Product Change Notification - SYST-24EBIU654

ERRATA - dsPIC33CK256MP508 Family Silicon Errata and Data Sheet Clarification

Description of Change:

FIGURE 1-1: I/O RAMP

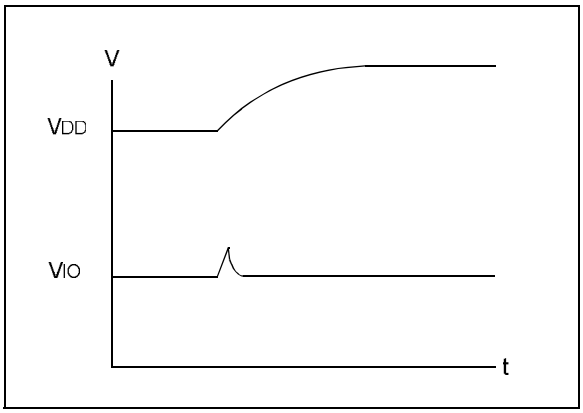
24. Module: I/O

During a fast device power-up when the VDD ramp is less than 4 mS, the I/O pins may drive up to 100 µA current for a duration of up to 10 µS (Figure 1-1).

Work around

1. Slow down the VDD ramp time (greater than 4 mS for VDD to ramp 0V to 3.3V).
2. Ensure the circuitry that is connected to the pins can endure this pulse.

Example applications affected may include complementary power switches, where a transient current shoot-through might occur. High-voltage applications with complementary switches should power the high-voltage 200 µSec later than powering the dsPIC® device to avoid the current shoot-through. This behavior is specific to each device and not affected by aging.
